RECONSTRUCT RUNWAY 4-22

TUSCALOOSA NATIONAL AIRPORT
TUSCALOOSA, ALABAMA

ADDENDUM No. 1

May 05, 2020

PROJECT LAYOUT PLAN

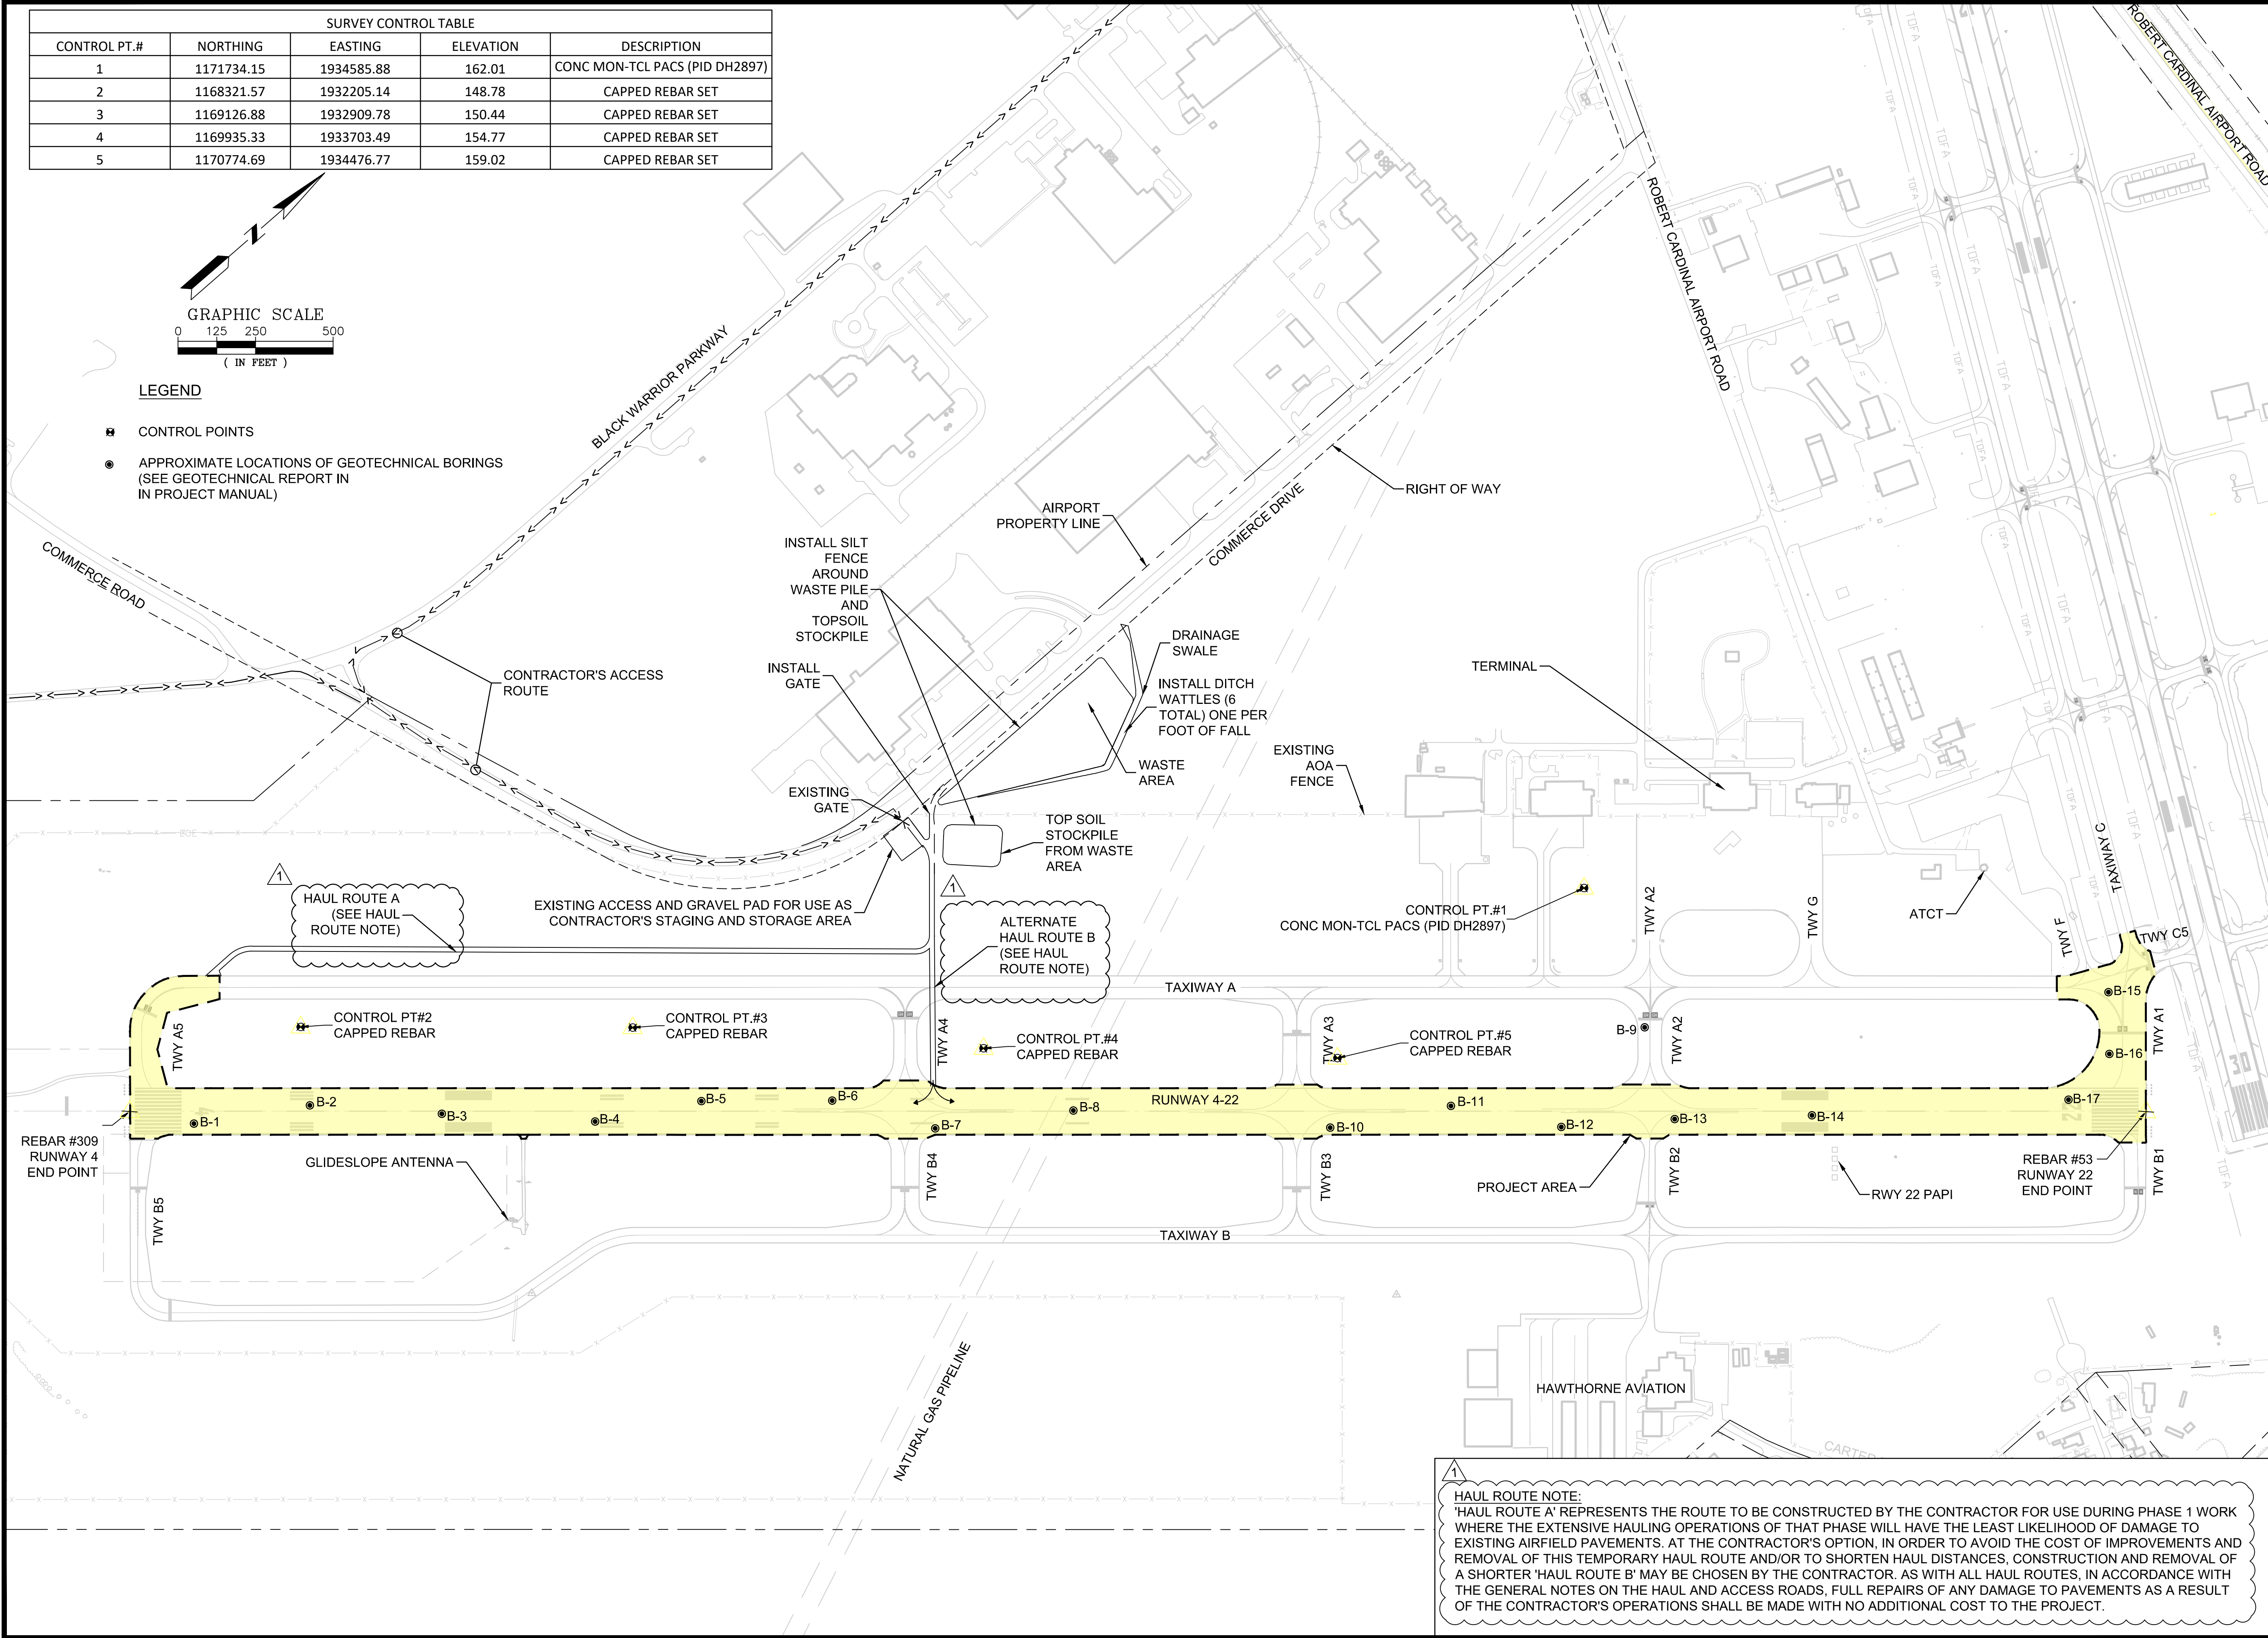
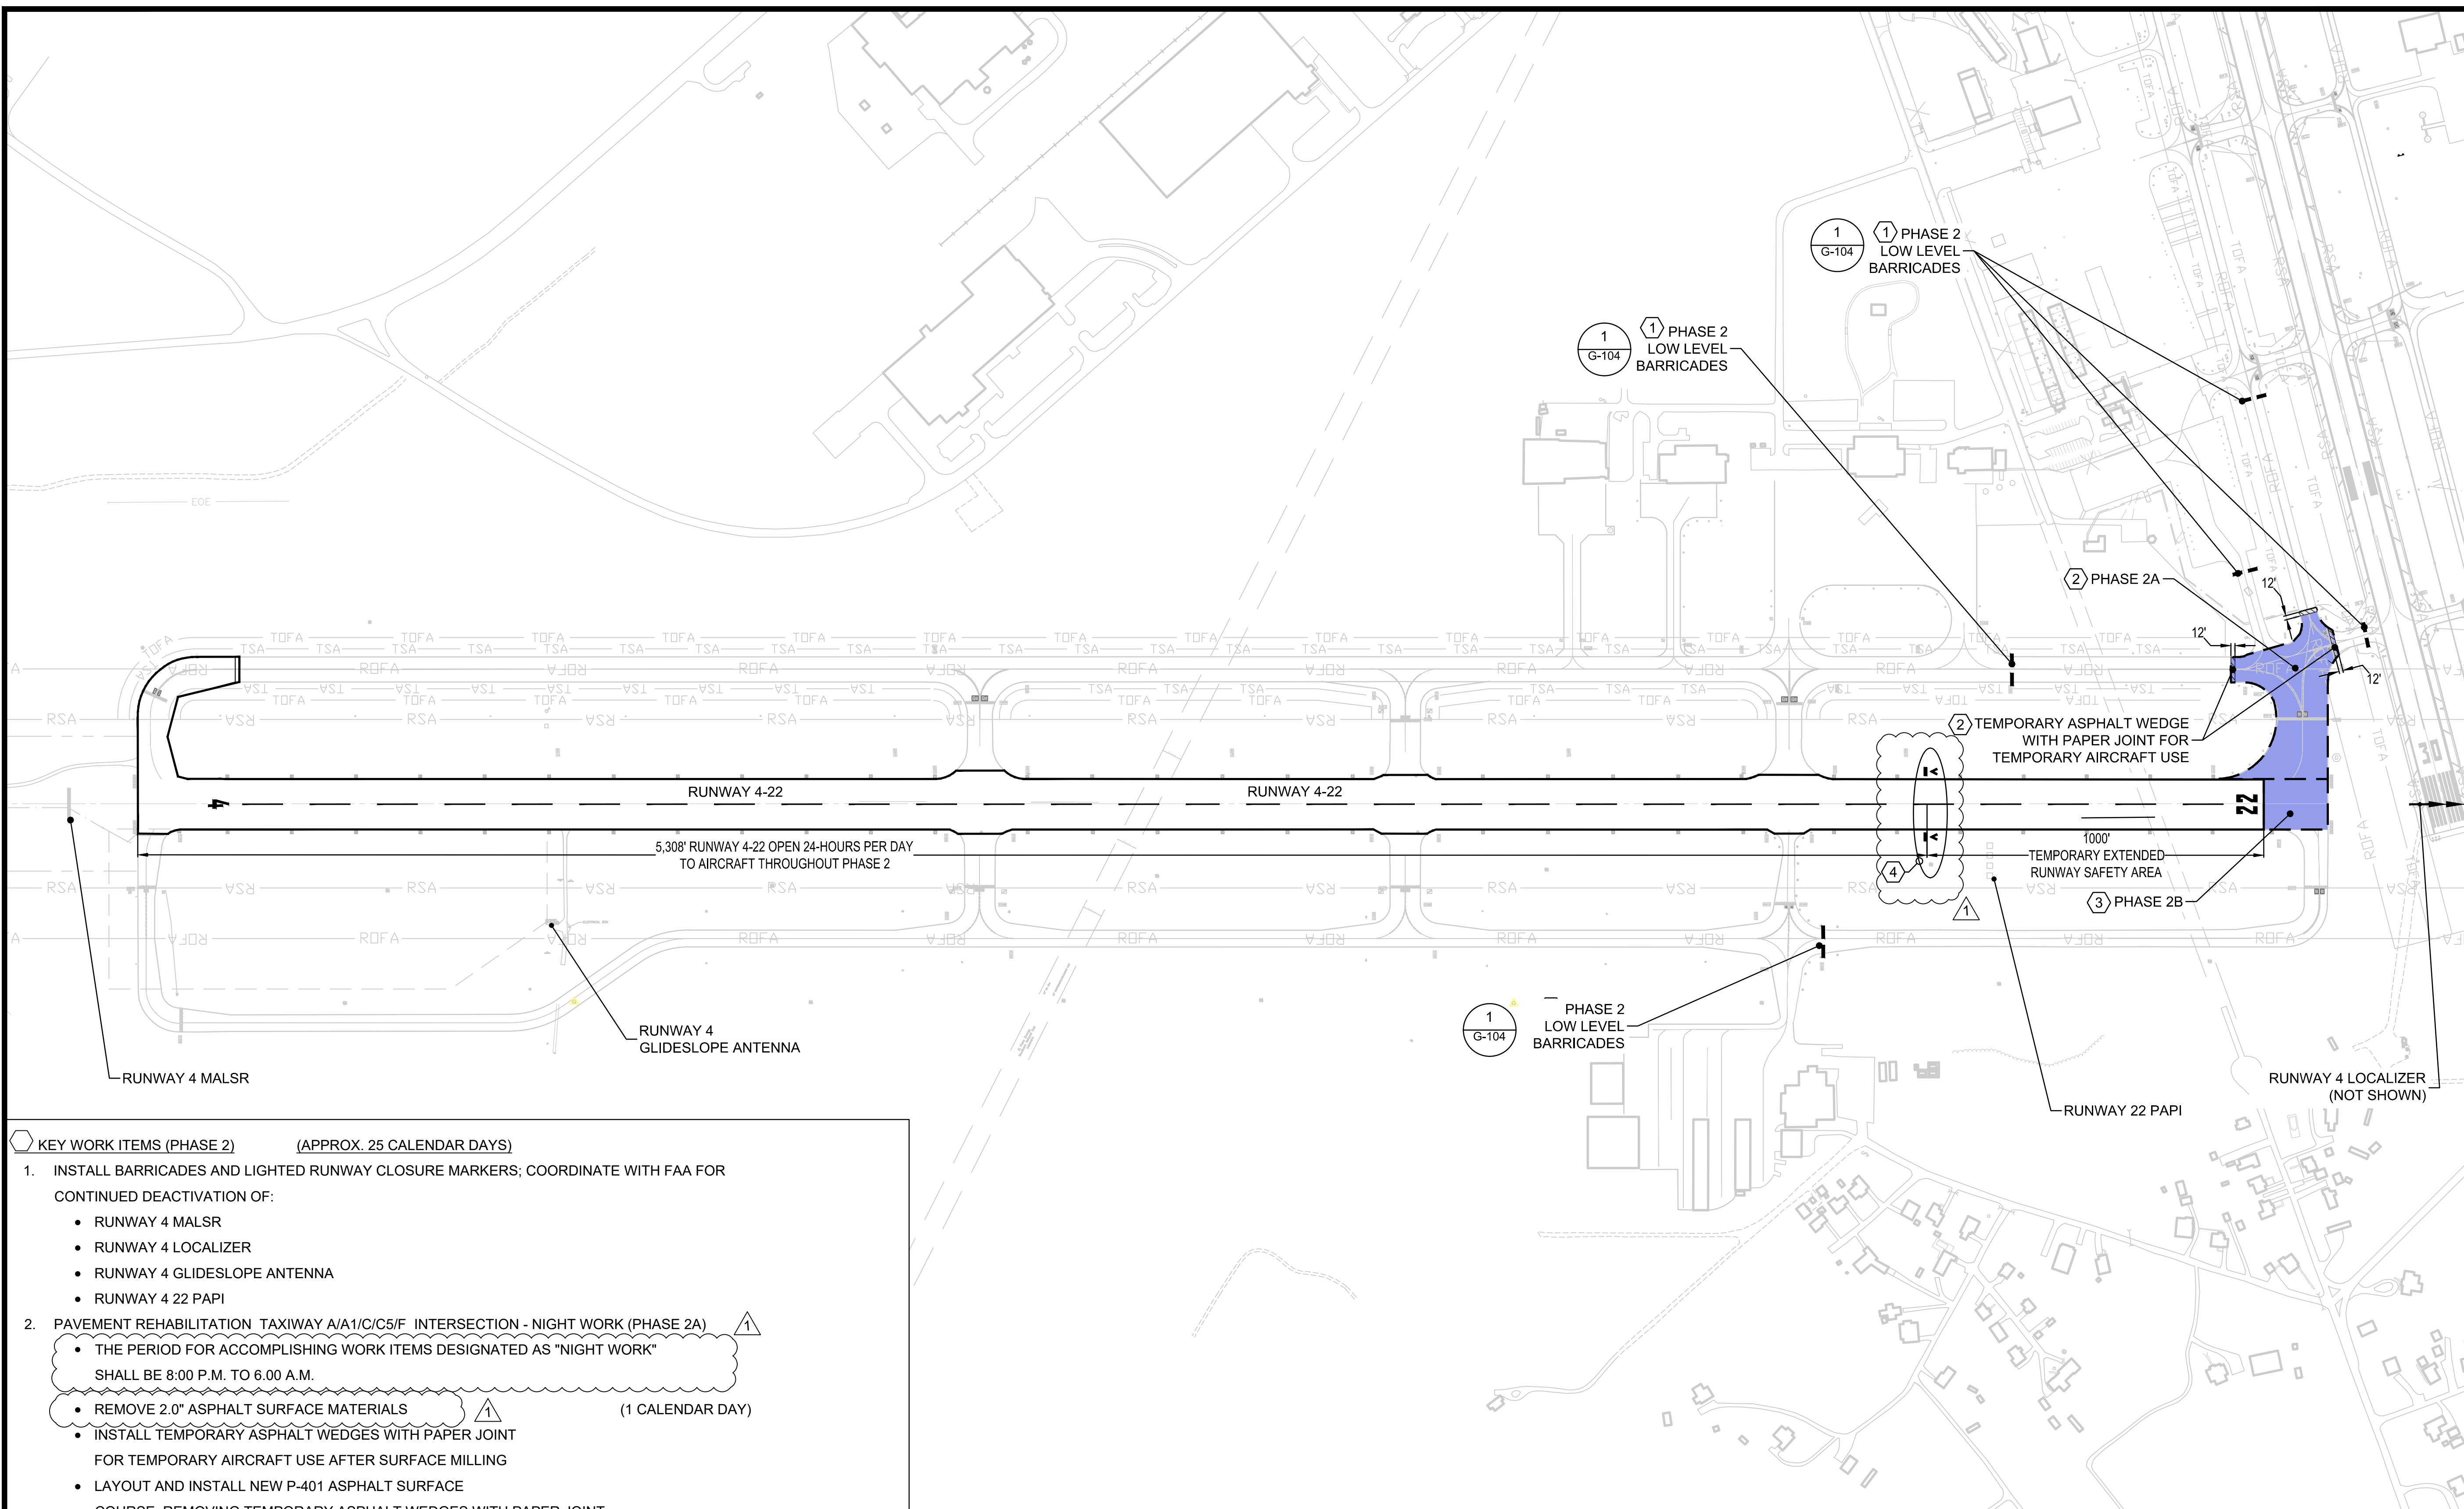
1. Sheet G-104, Project Layout Plan, **REPLACE** this sheet with the like-numbered sheet included with this transmittal. This sheet is revised to provide an alternative haul route to the one originally shown.

'HAUL ROUTE A' REPRESENTS THE ROUTE TO BE CONSTRUCTED BY THE CONTRACTOR FOR USE DURING PHASE 1 WORK WHERE THE EXTENSIVE HAULING OPERATIONS OF THAT PHASE WILL HAVE THE LEAST LIKELIHOOD OF DAMAGE TO EXISTING AIRFIELD PAVEMENTS. AT THE CONTRACTOR'S OPTION, IN ORDER TO AVOID THE COST OF IMPROVEMENTS AND REMOVAL OF THIS TEMPORARY HAUL ROUTE AND/OR TO SHORTEN HAUL DISTANCES, CONSTRUCTION AND REMOVAL OF A SHORTER 'HAUL ROUTE B' MAY BE CHOSEN BY THE CONTRACTOR. AS WITH ALL HAUL ROUTES, IN ACCORDANCE WITH THE GENERAL NOTES ON THE HAUL AND ACCESS ROADS, FULL REPAIRS OF ANY DAMAGE TO PAVEMENTS AS A RESULT OF THE CONTRACTOR'S OPERATIONS SHALL BE MADE WITH NO ADDITIONAL COST TO THE PROJECT.

| SHEET NO. G-204 | | | | REV.  | |

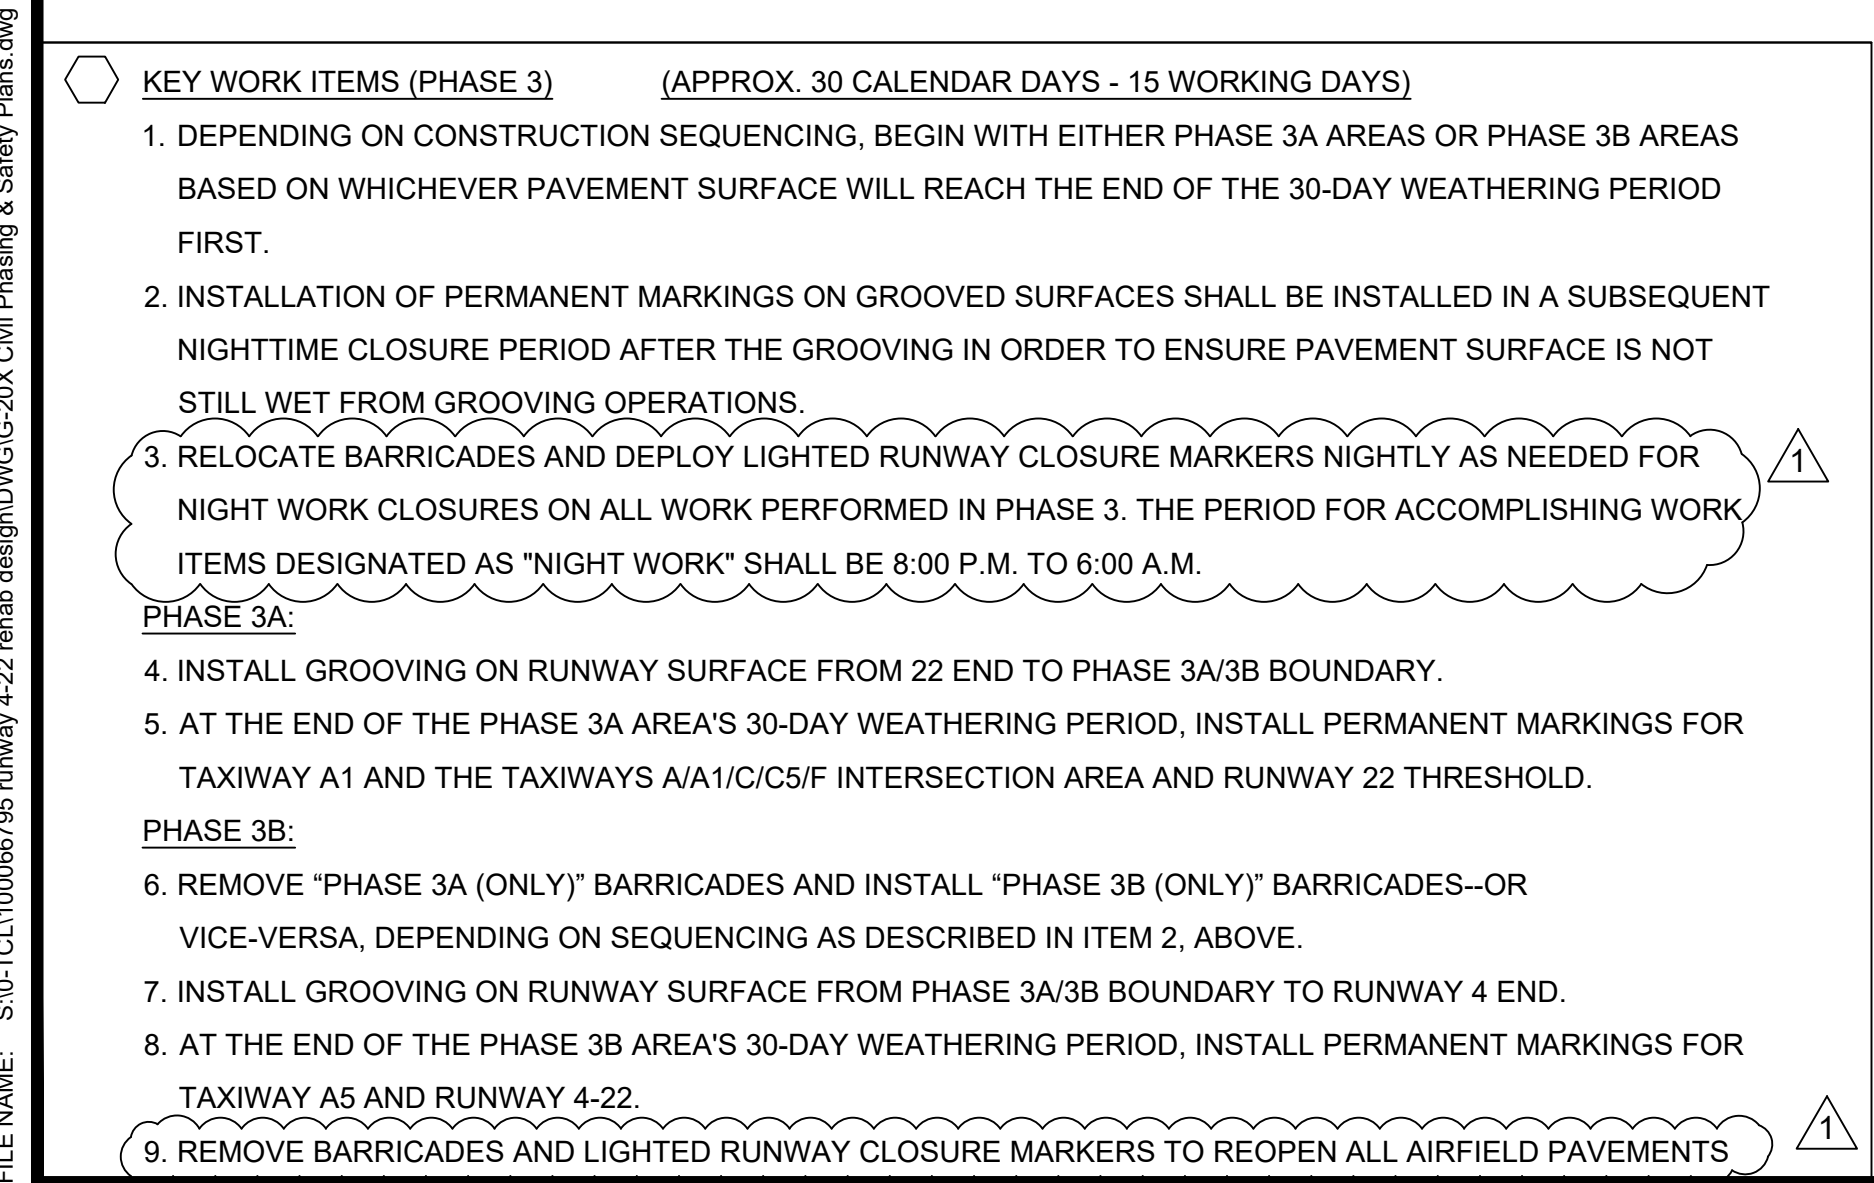
- The haul route is shown, along with the flaggers necessary to coordinate with the ATCT for safe movement of truck traffic to and from the work area.
4. Sheet G-204, Construction Safety and Phasing Plans – Phase 3, **REPLACE** this sheet with the like-numbered sheet included with this transmittal. The purpose of this change is to:

- Eliminate the previous reference to the displaced threshold marking and lighting on this sheet. The temporary threshold displacement is now intended to be removed at the end of Phase 2 work.

- Revise note 3 to define the hours during which all of the Phase 3 ‘Night Work’ is to be accomplished.
 - Renumber the keyed notes after the removal of the note that had been previously referring to the displaced threshold lighting and marking.

- Depict the second lighted runway closure marker that will be needed at the Runway 22 end for the full closure of the runway during the night work efforts required in Phase 3.
